Development at Gowan Motors
Site, Naas Road

Walking Audit

Document Ref: P23063-PMCE-XX-XX-RP-QA-GEN-1_00_02

2.1 Ladder and Tramline at the start/end of shared facilities.

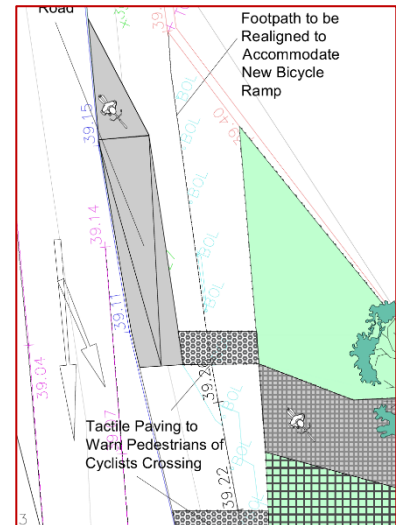
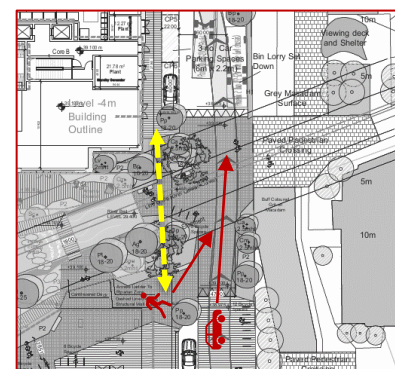
Tactile paving has been indicated on both sides of the access at the northwest of the proposed development where it is intended that cyclists would travel between the Naas Road and the development's underground Bike Store via this access. A ramp has been indicated at this location to allow cyclists to leave the Naas Road carriageway and enter the development.

Tactile paving has been indicated within the footway on both sides of this access however the type of tactile paving proposed is unclear. Should 'Ladder and Tramline' tactile paving not be provided on the north-eastern side of the access where the footway and cycle track transition to a shared path, this may result in visually impaired pedestrians, travelling northeast, inadvertently descending the ramp and entering the cycle.

In addition, should warning tactile paving not be provided on the south-western side of the access, there is a risk that visually impaired pedestrians may be insufficiently aware that they have entered/exited an area shared with cyclists, increasing the risk of cyclist-pedestrian collisions.

The Cyclist ramp on Naas Road should be removed and dropped kerbs (similar to dwellings vehicular access) should be provided to allow cyclists to access the development.

Should the Cyclist ramp on Naas Road be retained, 'Ladder and Tramline' tactile paving, of an appropriate depth, should be provided on the north-eastern side of the access and warning tactile paving should be provided on the south-western side of the access where the segregated facilities transition to the shared surface.

The profile of the Ladder and Tramline, and warning, tactile paving should be in accordance with, "Guidance on the Use of Tactile Paving Surfaces (2021)."

Walking Audit Reference	Summary of Issue	Design Team Response/Action
2.1	Ladder and Tramline at the start/end of shared facilities	The cyclist ramp at this location has been removed, and the footpath is now continuous along the side of the Naas Road.

2.3 Benches

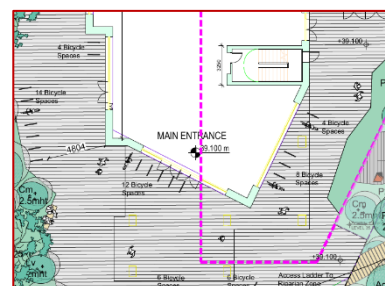
Benches are indicated within the development. However, information regarding the type of benches to be provided has not been provided and it is therefore unclear if they will be accessible to a wide variety of road users. Benches whose bases are narrower than the rest of the bench can create difficulties for long-cane users in detecting and avoiding collision with the bench.

To accommodate the widest possible mix of disabilities a mixture of benches with & without armrests should be provided. The benches should have solid bases and no part of the bench should protrude beyond the extents of the base.

2.2	Discontinuous footway	Site Layout has been revised to provide a continuous footway at this location
2.3	Benches	The issue has been passed on to the Landscape Architect and will be picked up in their layouts

2.5 The absence of continuous pedestrian accesses/links to Carriglea

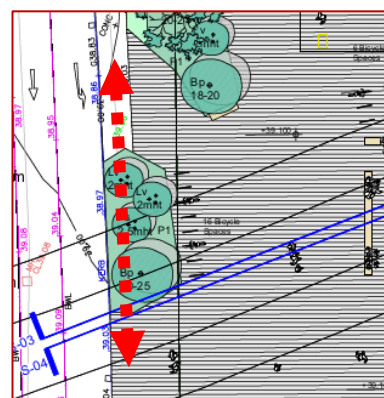
Pedestrians accessing Carriglea via the crossing between Blocks D and L may be unlikely to circumnavigate the parallel car park south of block 2 when wishing to gain entry to the southern development, preferring instead to walk through the landscaped area or emerge from between the cars. The creation of an informal pedestrian route may lead to the deterioration of the grassed area, resulting in ponding and uneven/unstable ground.

A direct and continuous pedestrian route should be provided to cater for the desire line.

2.4	Blocked Building Access	Bicycles have been relocated to avoid any blockages
2.5	The absence of continuous pedestrian accesses/links to Carriglea	Future Potential linkages to Carriglea are now indicated on the landscaping drawing.

2.7 Street furniture on footway.

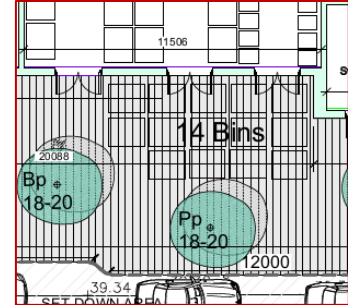
The existing lighting column, signal head and sign column are located in the middle of the footway along the Naas Road. This may create difficulties for vulnerable road users travelling within the footway.

All street furniture should be located/relocated to the rear of the footway and outside the pedestrian desire walking lines.

2.6	Tree Pit within Existing Footway	Footway along the Naas Road has been realigned to provide a continuous path, with no obstructions.
2.7	Street furniture on footway.	The footway along the Naas Road has been realigned 1.5m away from the current line of the kerb, which will provide a continuous, unobstructed path.

2.9 Dropped Kerb at Mobility Parking Space

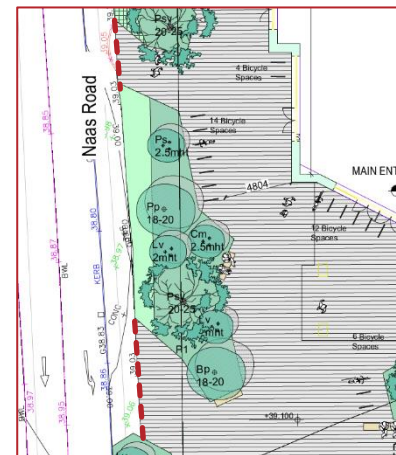
A mobility impaired parking space has been indicated within the proposed development to the east of Block 2. Cross-section 'S-07' indicates that a kerb would be located to the rear of the parking space between the space and the adjacent shared surface. No dropped kerb has been indicated adjacent to the mobility parking space. This would lead to mobility-impaired vehicle occupants having to travel within the area shared with motorised vehicles to find a suitable access location.

A dropped kerb, and associated tactile paving, should be provided adjacent to the mobility impaired parking space.

2.9	Dropped Kerb at Mobility Parking Space	A continuous 2m wide route has also been provided adjacent to the kerb for pedestrians.
2.10	Transition between Public Footway and the Development's Shared Surface	Dropped kerbs have been added to the site layout.
